Answer to the comments of reviewer and corresponding modifications

Dear Reviewer #1,

Figure 8: Normalized shear force on the footing for different modal damping ratios.

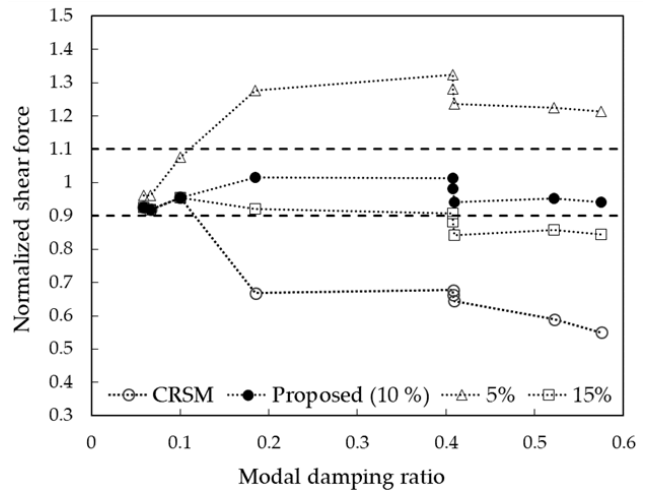
3.	<p>The damping ratio that was found for the 3rd mode and Soil Type was equal to 40.8. Indeed, it is an excessive number. However, this manuscript describes a specific case, for which this high value was calculated. There is a chance that the application of the current method for another case (different soil type, different wind turbine supporting structure etc.) will lead to another value for the damping ratio, for example, 15%. So, what should someone do in this case? Which is the limit of the damping ratio over which the substitution</p>	<p>Based on the reviewer's comment, the authors added additional cases with different soil conditions to the parametric study in the revised manuscript to vary the damping ratio of the most dominant mode on the shear force acting on the footing from 6 % to 58 %. The figure below (Fig. 8 in the revised manuscript) shows that the threshold value $\zeta_{thr} = 0.1$ results in accurate estimates of the shear force on the footing for all case while no consideration of the threshold or $\zeta_{thr} = 0.15$ result in underestimates and $\zeta_{thr} = 0.05$ results in overestimates. It is thus concluded in this study that 0.1 is a reasonable choice for the limit of the damping ratio over which the substitution should be take place. This parametric study is summarized in the lines 313-337 in the revised manuscript.</p>

should take place? In other words, the method that is presented by the authors should have somehow a more general validity and should not be highly case-specific and highly dependent on engineering judgment.
